Town of Arlington, MA Redevelopment Board

Agenda & Meeting Notice September 27, 2021

9:15 p.m. **Docket #3665, 645 Massachusetts Avenue**

Town of Arlington, Massachusetts
Department of Planning & Community Development
730 Massachusetts Avenue, Arlington, Massachusetts 02476

East Elevation - David Lamson Way

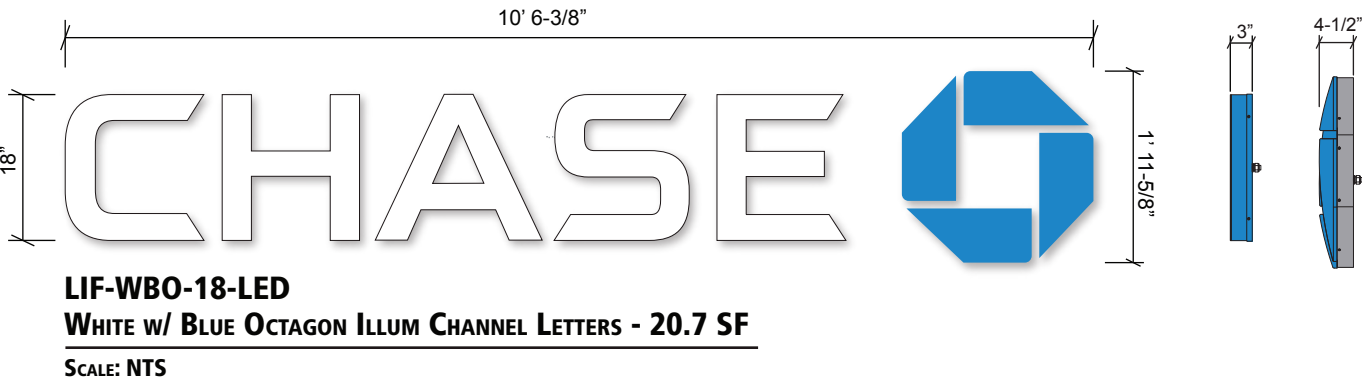
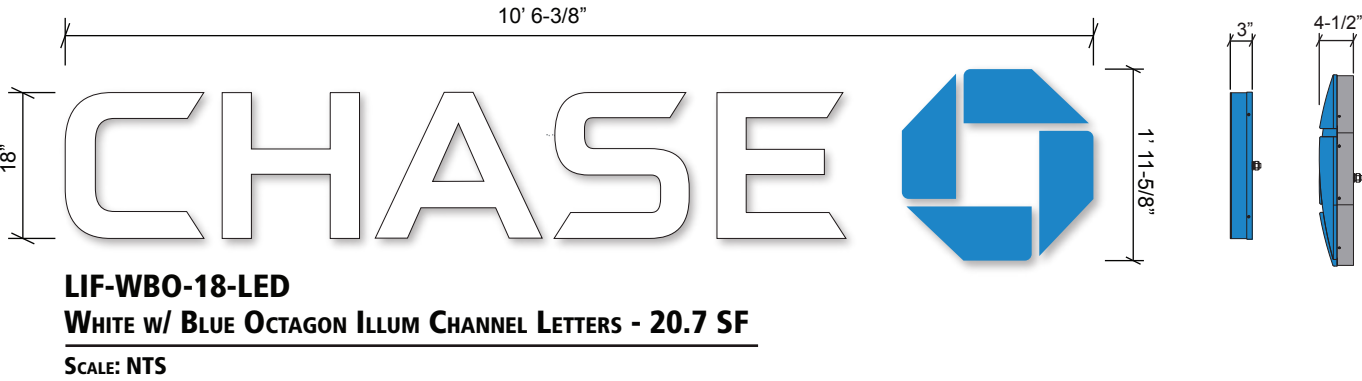
Regarding the windows along the Massachusetts Avenue and David Lamson Way facades, the renderings and elevations in the sign package show that the gridded windows will be replaced with commercial windows. It appears from the renderings that the glazing has also been addressed. Specifications on window type and glazing have not been provided.

Façade: The board recommended changing the existing gridded windows to match the proposed new windows. THE RENDERINGS HAVE BEEN REVISED TO INCORPORATE THIS CHANGE

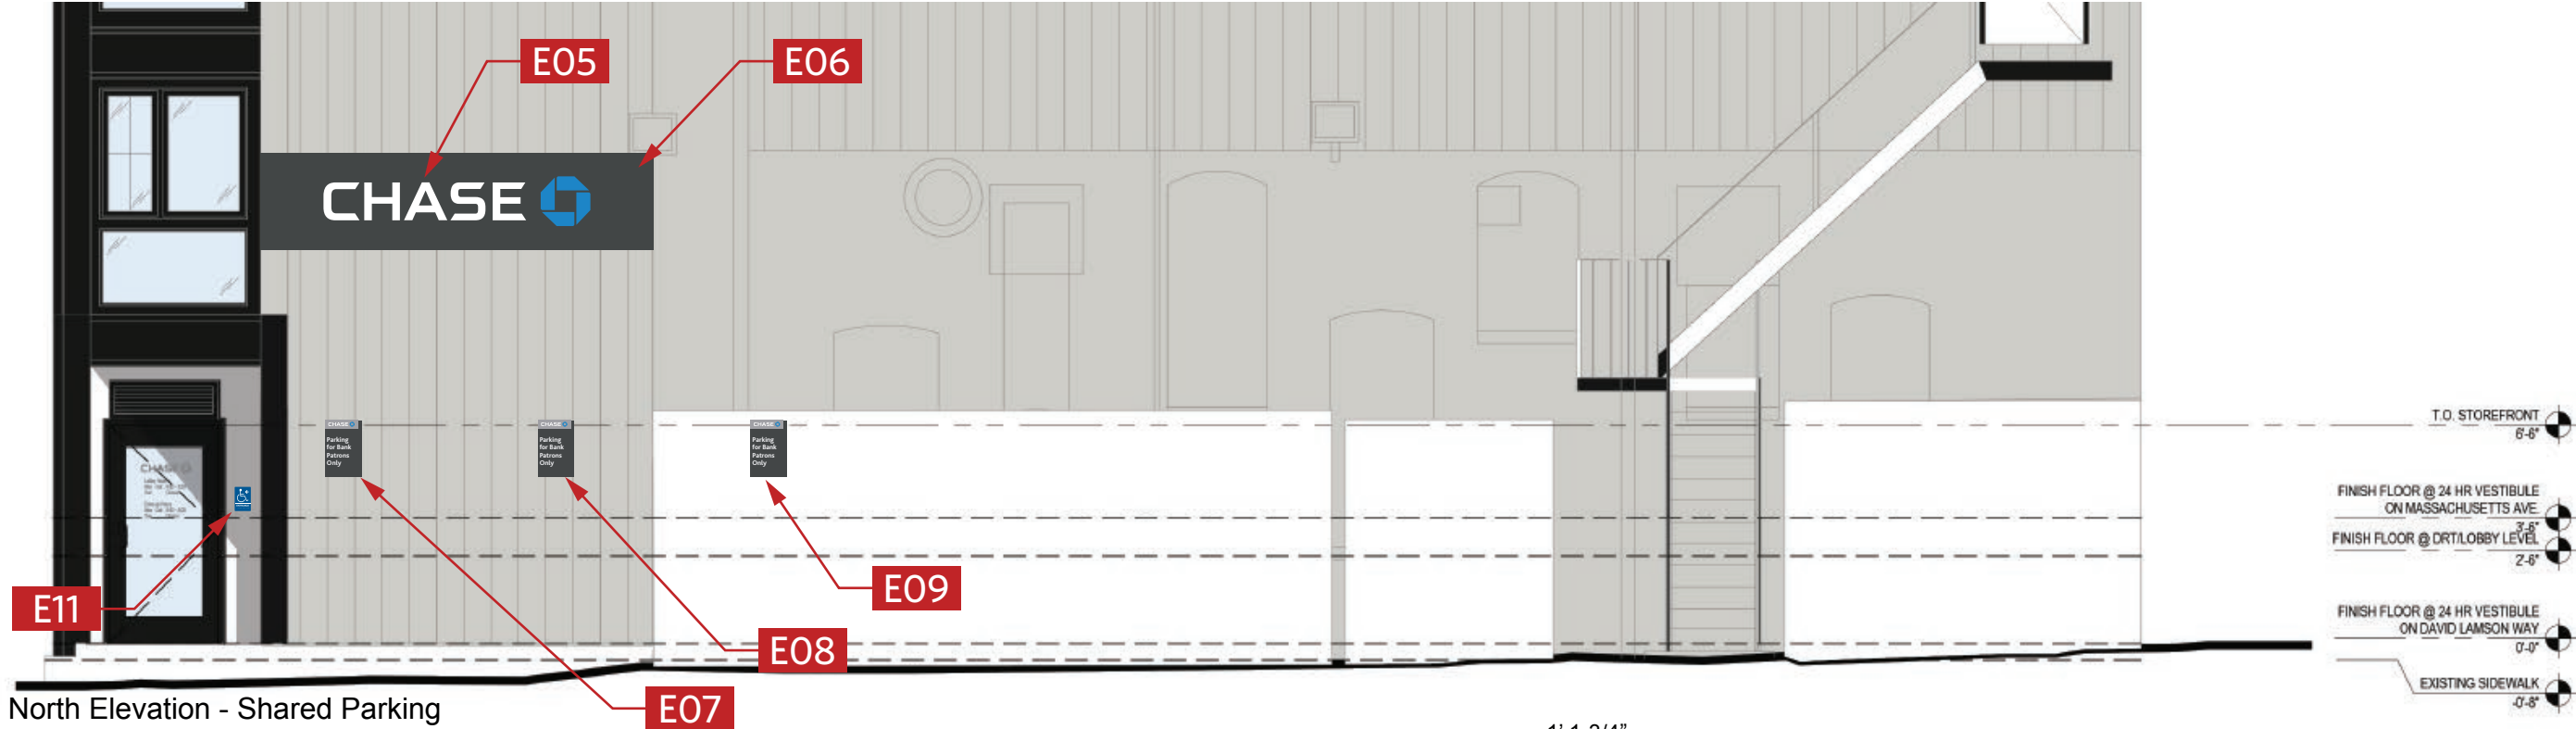
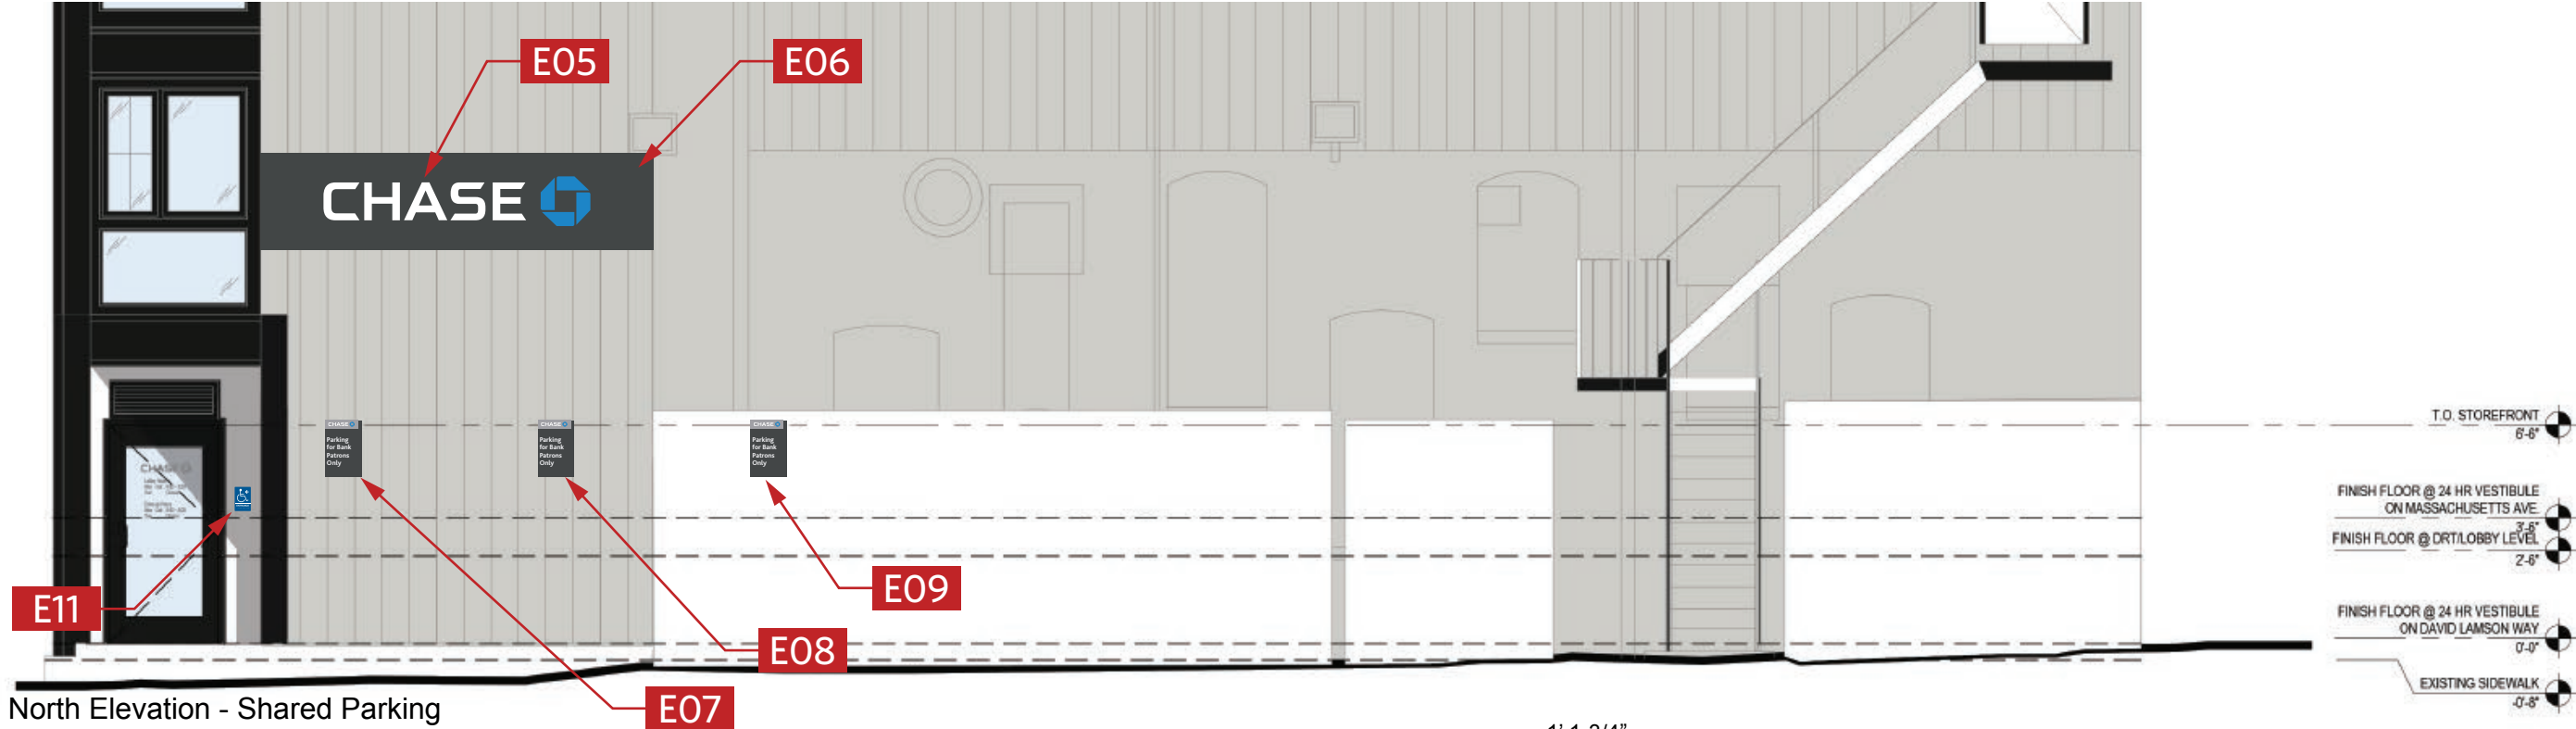
Signage: The board was not in favor of the proposed blade sign. They believed the sign was not in keeping with other signage in the Central Business District as asked if we could consider moving the sign on the gray band along the alley side of the building. THE RENDERINGS HAVE BEEN REVISED TO INCORPORATE THIS CHANGE
